**FINAL DRAINAGE REPORT
FOR
MONUMENT JUNCTION DEVELOPMENT
HIGHWAY 105 CORRIDOR &
JACKSON CREEK PARKWAY
INTERSECTION IMPROVEMENTS**

February 2023

Job no. 1302.22

Pipe ID: **Pipe Run 2**

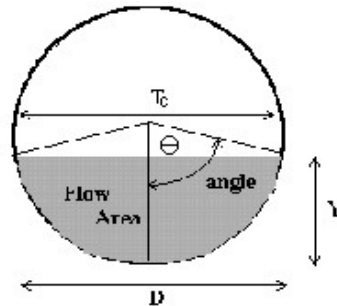
Verify pipe size-Appendix calculations say 18" and CD's say 24". Update so same size is referenced through all documents

100-yr HGL Calculations
Map Layout

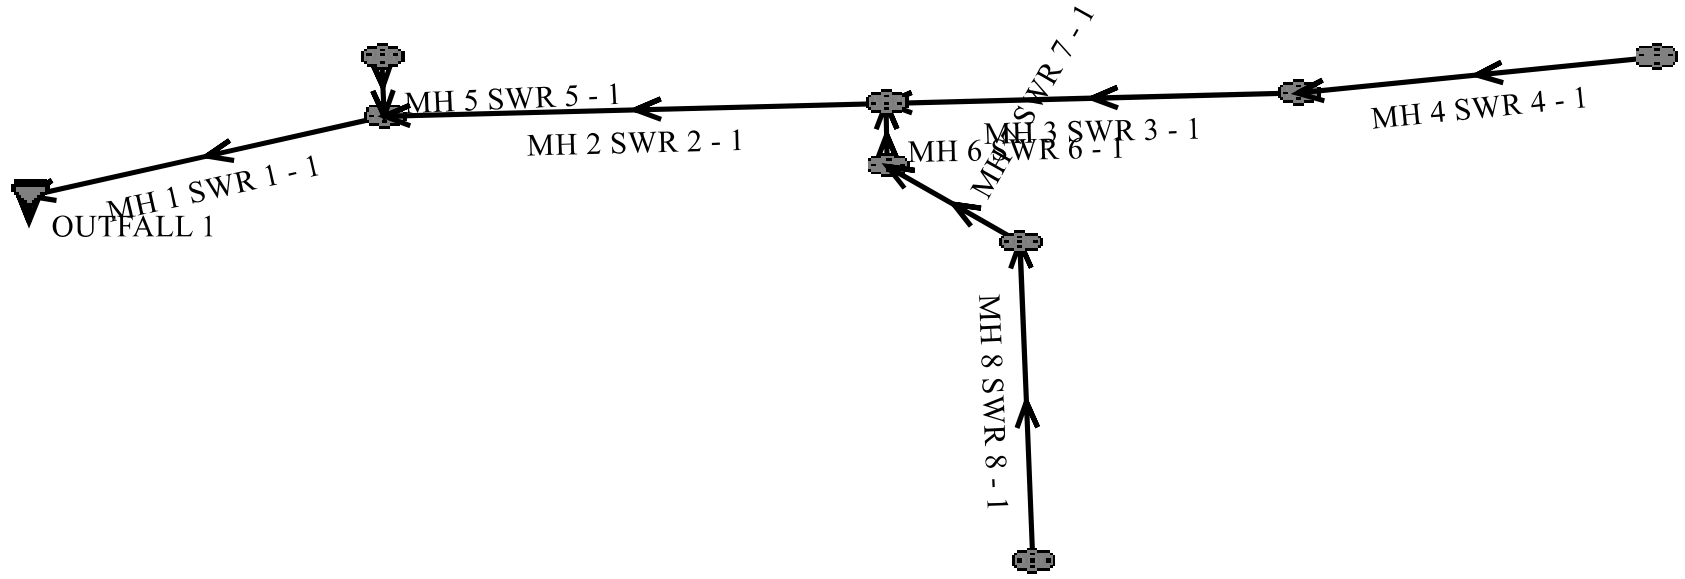
Include future inlet and pipe segment, to ensure system will function adequately upon future build-out
